ADDENDUM NO. 02

Project: Ridgeview Elementary School
701 Thornton Street, Liberty, Missouri 64068

ADDENDUM NO 02

NOTICE TO ALL BIDDERS FOR THE
Liberty Public Schools Ridgeview Elementary School

LIGHTING LEVEL 2 DEMO PLAN - AREA B

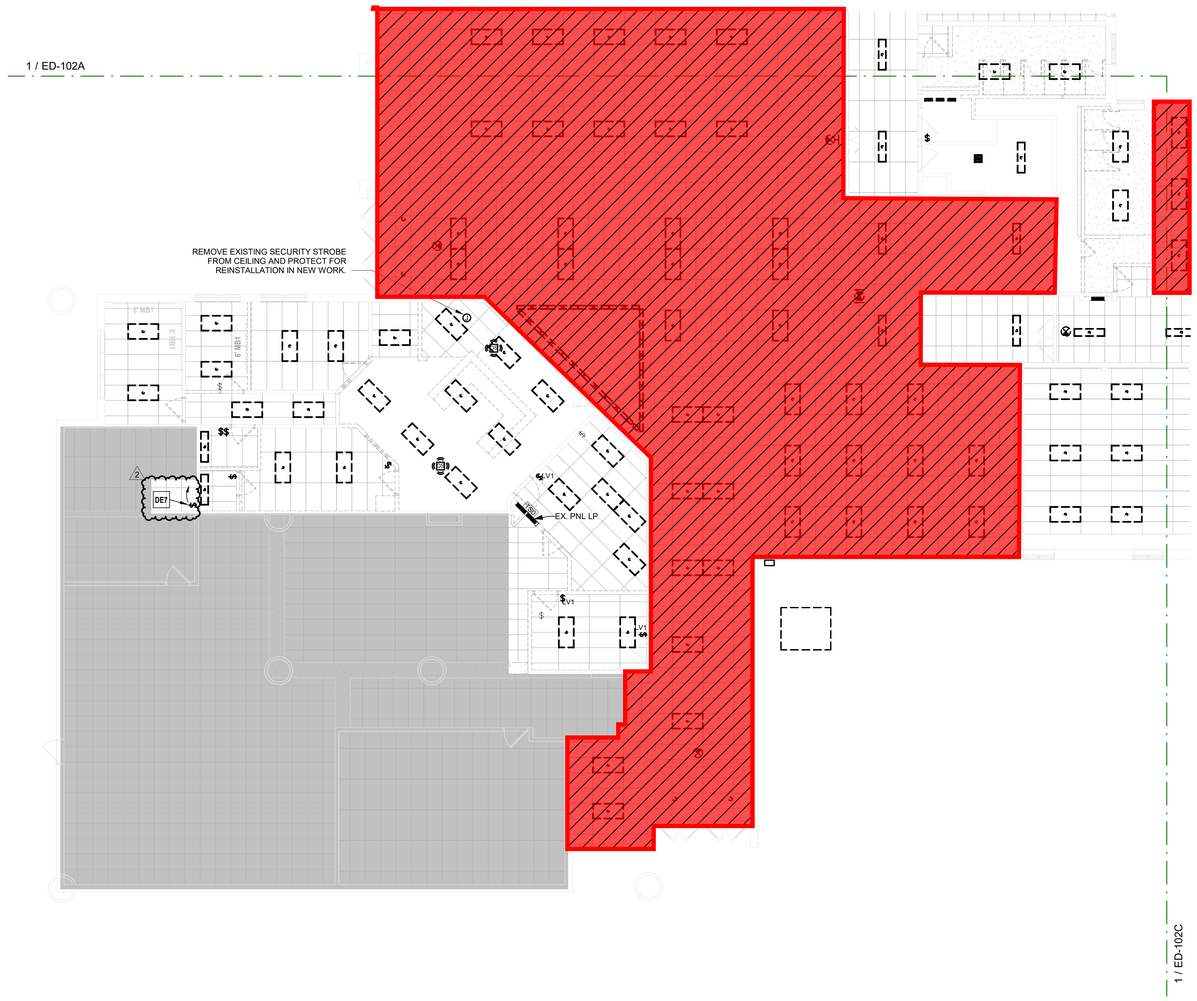
1. Sheet ED102B – LIGHTING LEVEL 2 DEMO PLAN – AREA B
   A. Added removal of light switch in media center.
2. Sheet ED202A – POWER LEVEL 2 DEMO PLAN – AREA A

POWER LEVEL 2 DEMO PLAN - AREA A

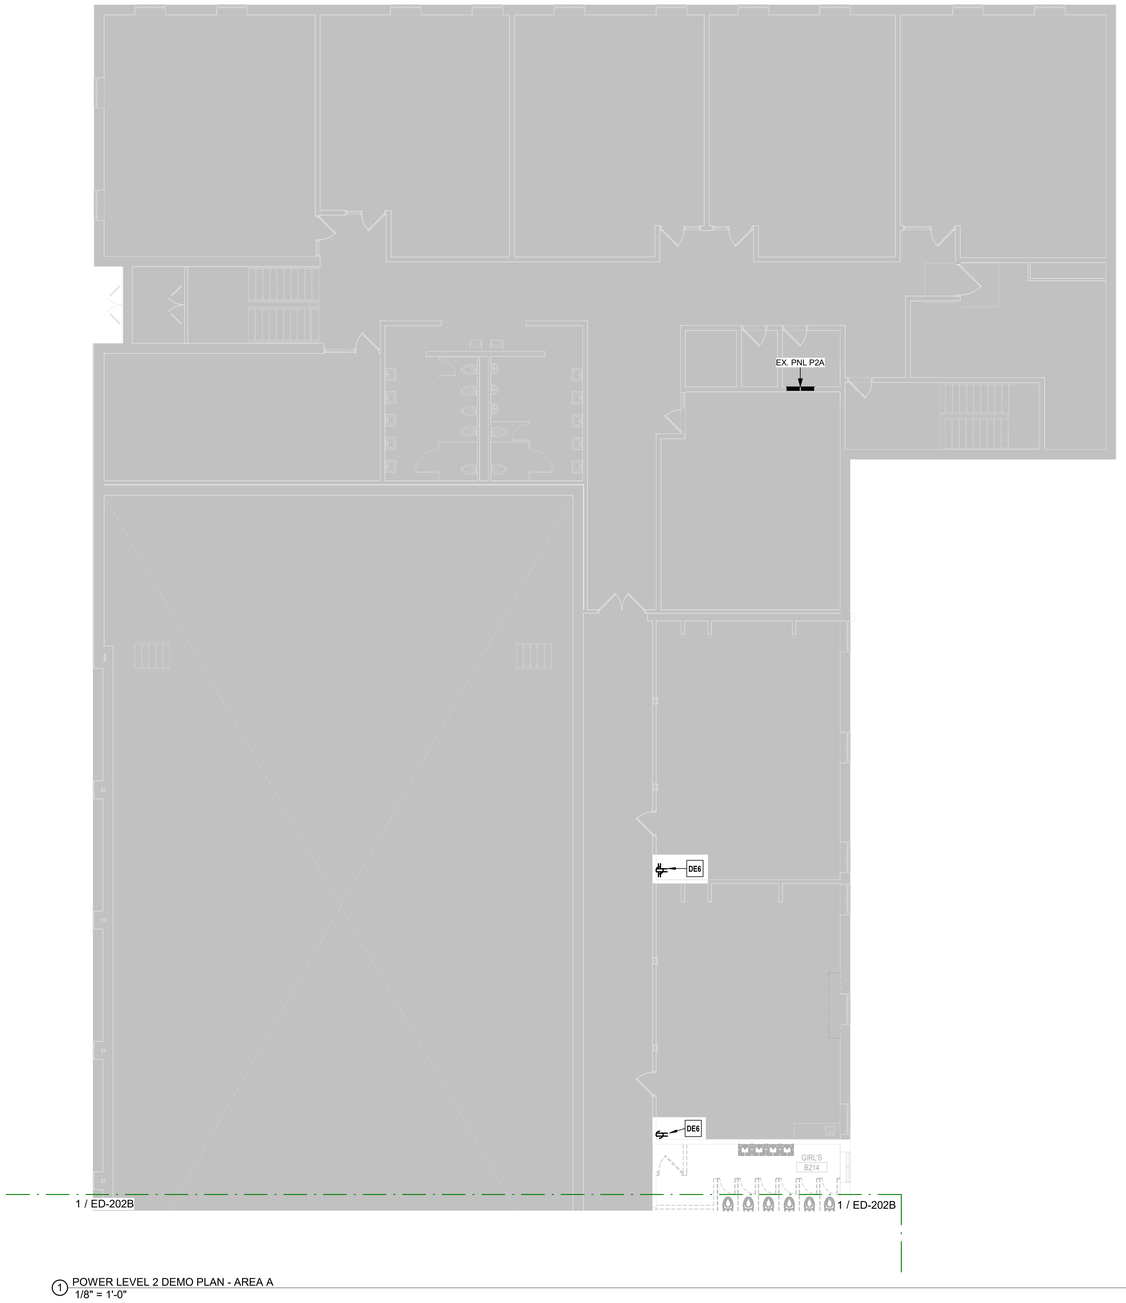
A. Added removal of receptacles in conflict with new duct chases.
3. Sheet ED202B – POWER LEVEL 2 DEMO PLAN – AREA B
   A. Added removal of 2nd floor box in office.

DE6 REMOVE RECEPTACLE AND ASSOCIATED CONNECTION TO ABOVE ACCESSIBLE CEILING TO ALLOW FOR INSTALLATION OF REPLACEMENT IN SAME GENERAL LOCATION. REFER TO NEW WORK PLANS FOR MORE INFORMATION.

POWER LEVEL 2 DEMO PLAN - AREA B

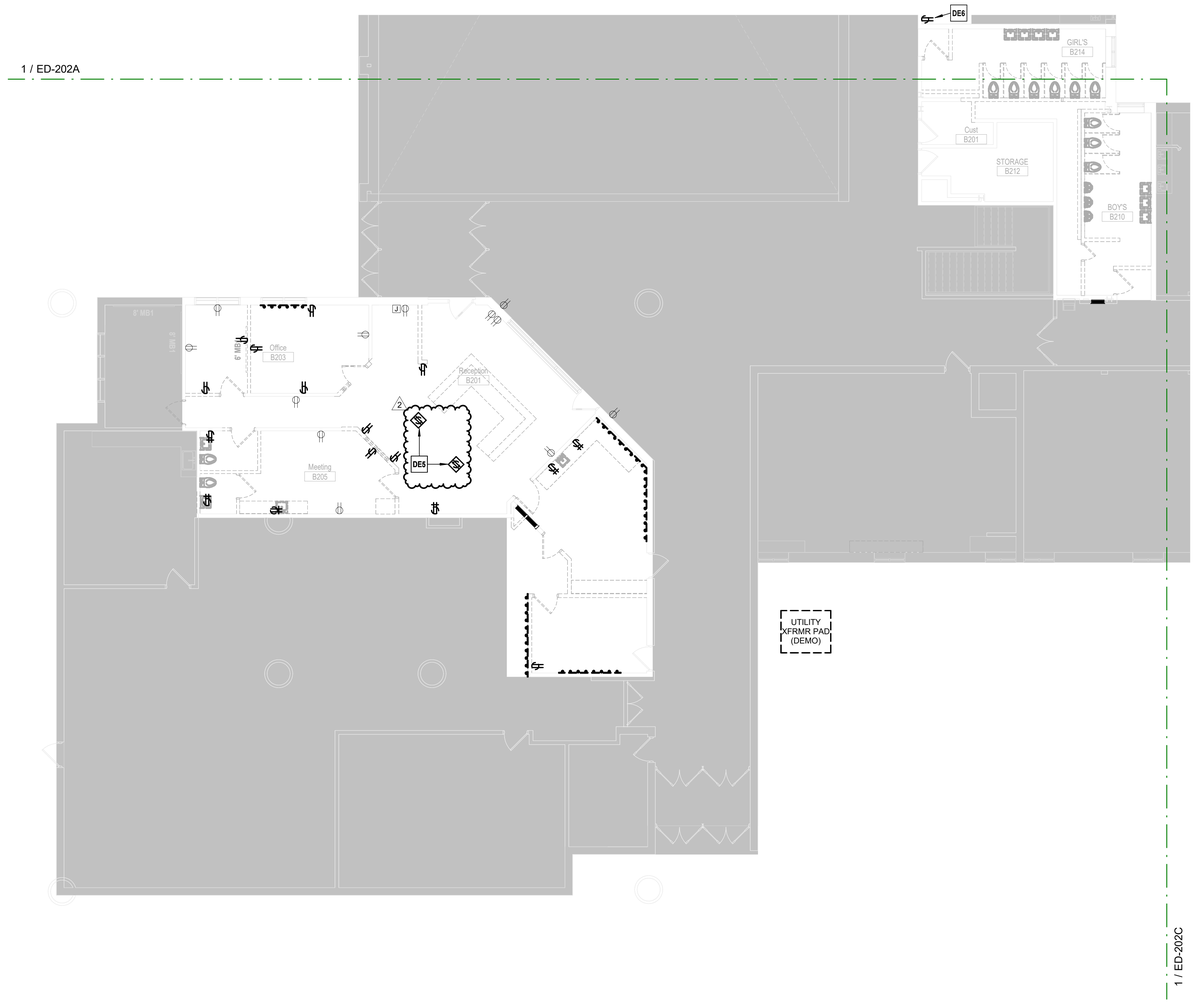
B. Added note to coordinate method of floor box removal.
4. Sheet E102B – LIGHTING LEVEL 2 PLAN – AREA B
   A. Revised lighting controls in Nurse B206 to including dimming.

DE6 REMOVE RECEPTACLE AND ASSOCIATED CONNECTION TO ABOVE ACCESSIBLE CEILING TO ALLOW FOR INSTALLATION OF REPLACEMENT IN SAME GENERAL LOCATION. REFER TO NEW WORK PLANS FOR MORE INFORMATION.

PLUMBING ROOF PLAN - AREA B

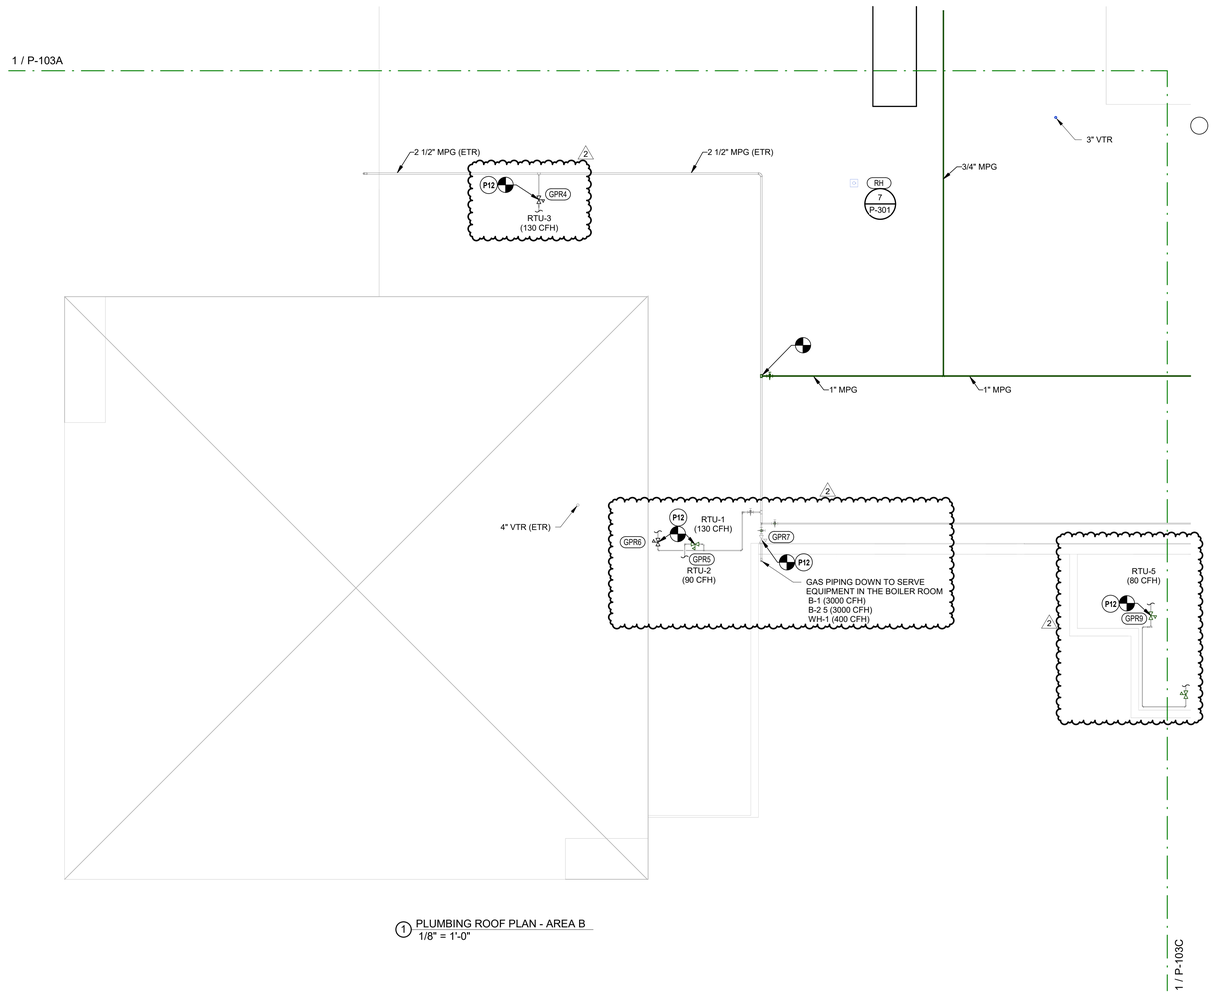
1. Sheet P-103B – PLUMBING ROOF PLAN – AREA B
   A. Replaced the existing gas pressure regulators (GPR's) and showed more existing gas piping.
   B. Added plan note P12.
2. Sheet P-103C – PLUMBING ROOF PLAN – AREA C
   A. Replaced the existing gas pressure regulators (GPR's) and showed more existing gas piping.
   B. Added plan note P12.
3. Sheet P-301 – PLUMBING SCHEDULES & DETAILS
   A. Revised the Gas Pressure Regulator Schedule.

2
P12 REMOVE EXISTING GAS PRESSURE REGULATOR AND INSTALL NEW GAS PRESSURE REGULATOR IN THE SAME LOCATION.

LIGHTING LEVEL 2 PLAN - AREA B

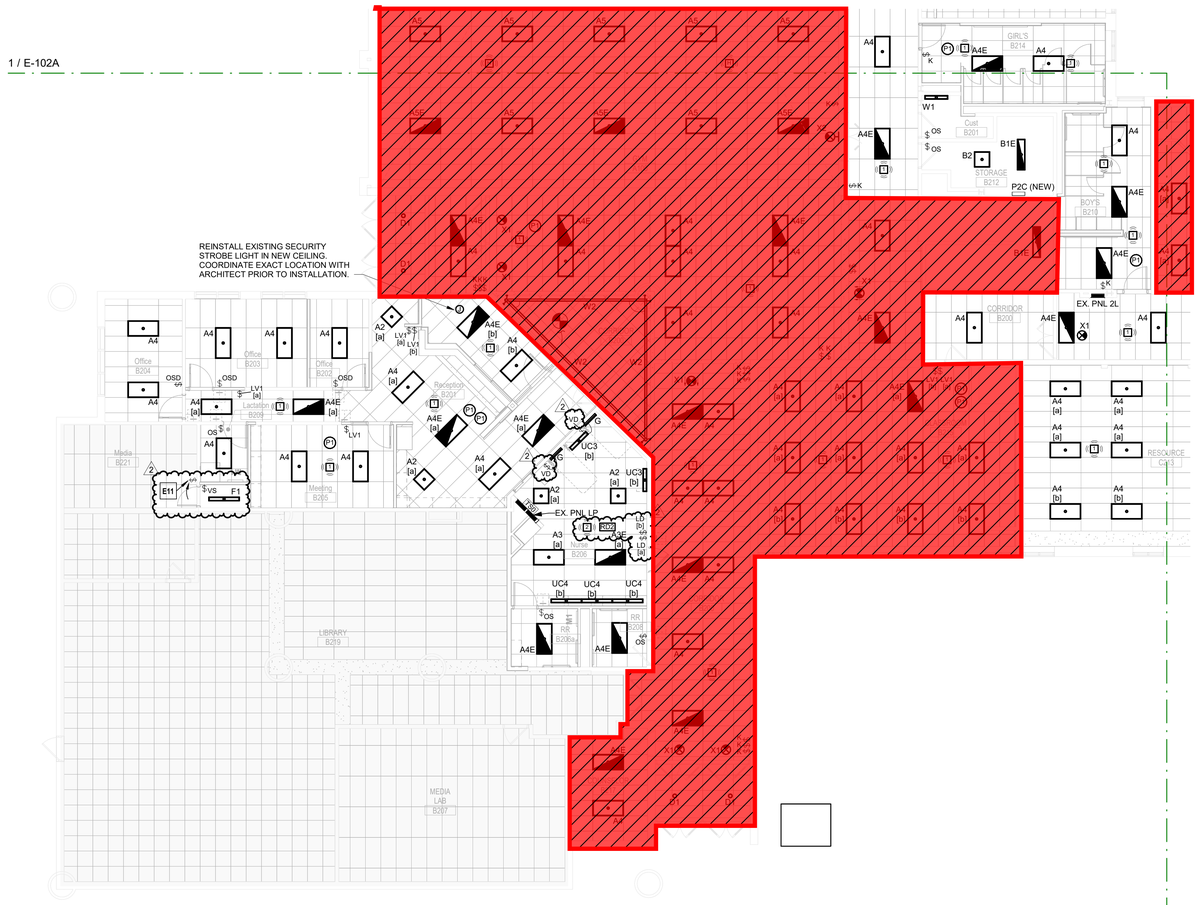
B. Added lighting to media center closet.
   C. Added replacement switch location for media center.
5. Sheet E202A – POWER LEVEL 2 PLAN – AREA A
   A. Added replacement receptacles on new chase walls.

POWER LEVEL 2 PLAN - AREA B

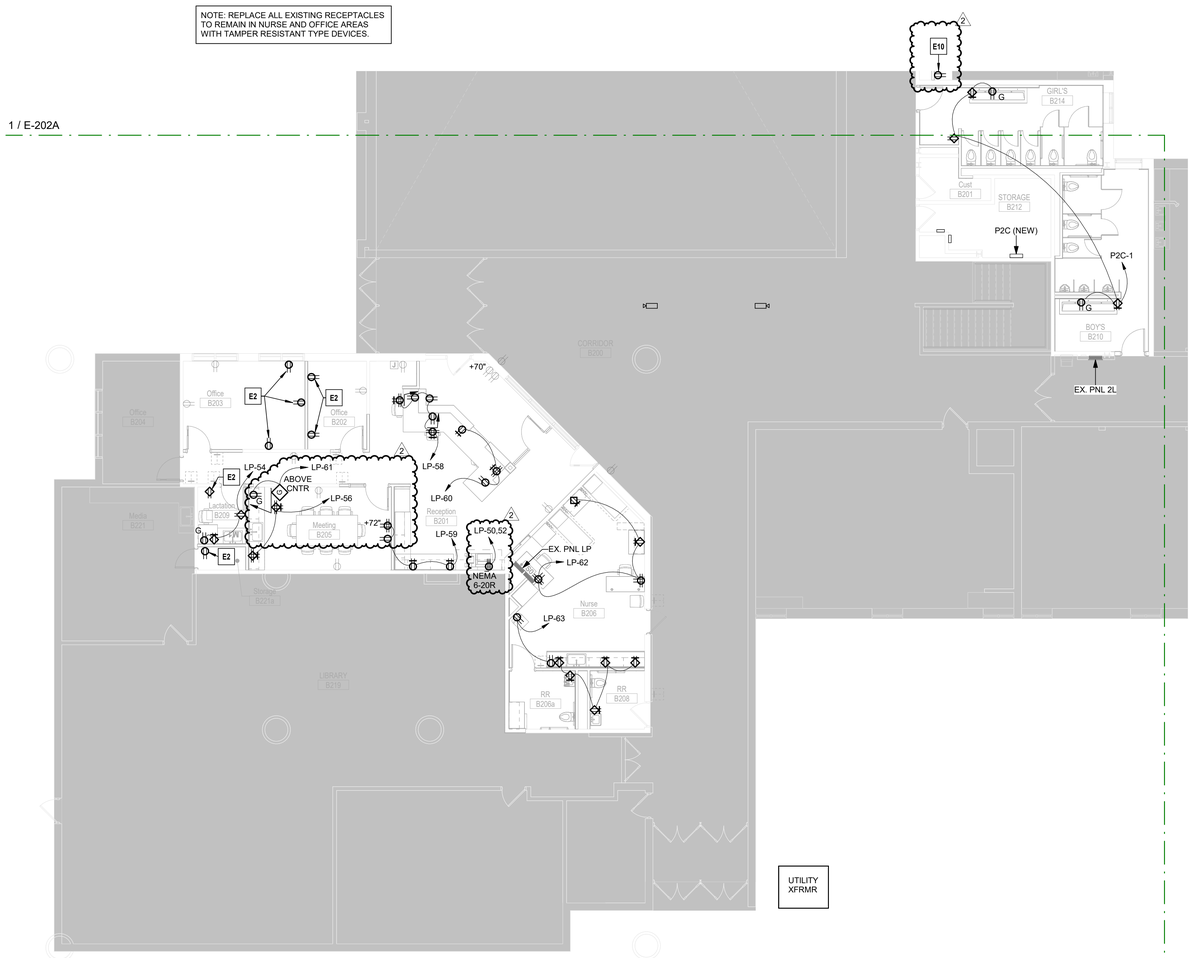
6. Sheet E202B – POWER LEVEL 2 PLAN – AREA B
   A. Removed above counter receptacles in Reception B201.
   B. Added receptacle for undercounter fridge.
   C. Revised circuiting to accommodate receptacle changes.

D. Revised connection for copier in Reception B201.
7. Sheet E500 – LIGHT FIXTURE SCHEDULE
   A. Added dimming lighting control devices.
   B. Added detail for connection of dimming lighting controls.

AUDIO-VIDEO LEVEL 2 PLAN - AREA B

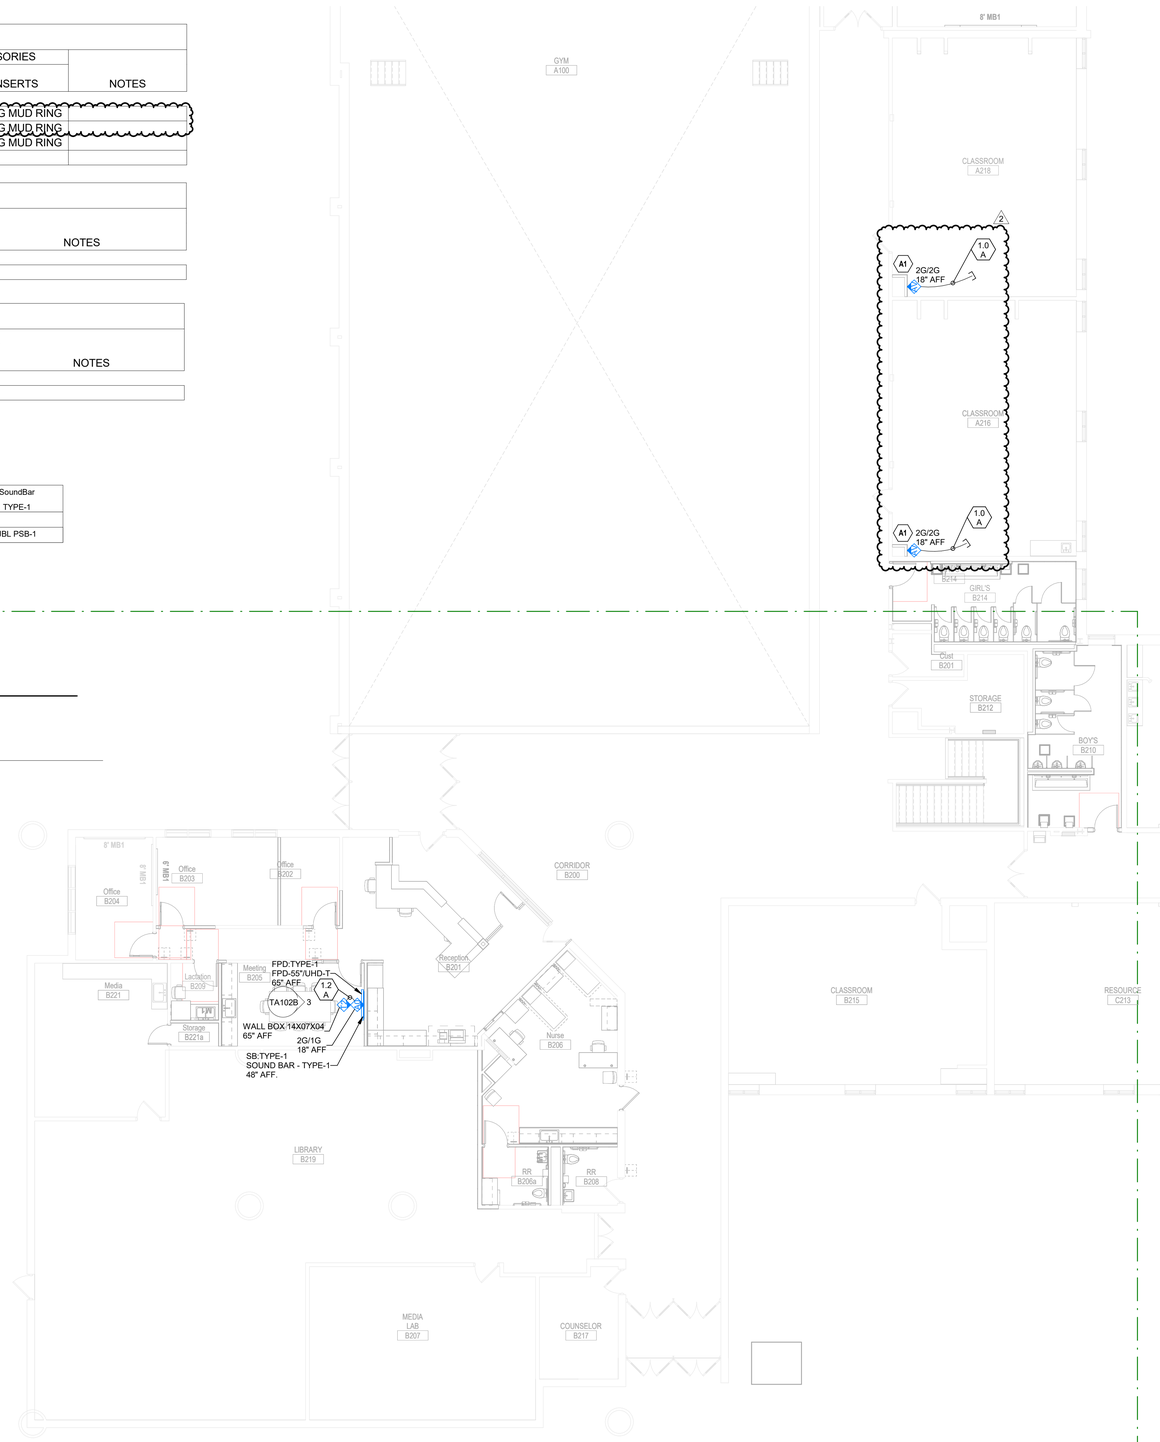
1. Sheet TA102B – AUDIO-VIDEO LEVEL 2 PLAN – AREA B
   A. Added connection box in classrooms A216 & A218.
   B. Revised Audio-Video Box Schedule.

TECHNOLOGY LEVEL 2 DEMO PLAN - AREA A

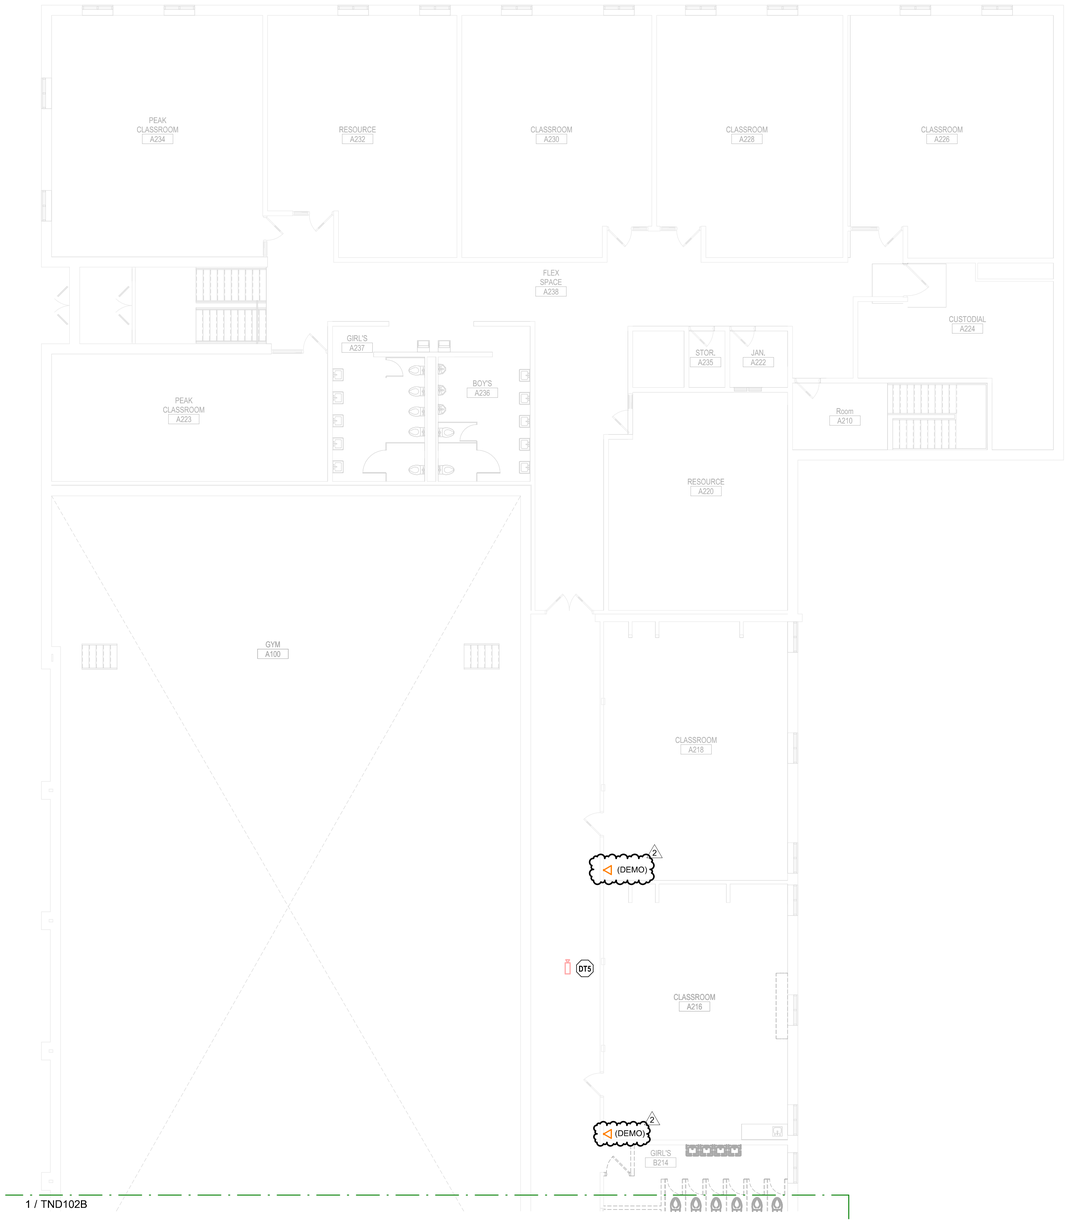
1. Sheet TND102A – TECHNOLOGY LEVEL 2 DEMO PLAN – AREA A
   A. Added data devices to demolish in Classroom A216 and A218.
2. Sheet TND102B – TECHNOLOGY LEVEL 2 DEMO PLAN – AREA B
   A. Relocated data devices per site visit photos and changed phasing from existing to remain to demolish in Reception B201.
3. Sheet TN102A – TECHNOLOGY LEVEL 2 PLAN – AREA A
   A. Added data drops on new chase wall in Classroom A216 and A218.
4. Sheet TN102B – TECHNOLOGY LEVEL 2 PLAN – AREA B
   A. Devices that were previously shown as existing to remain are not shown as they are being demolished in Reception B201.
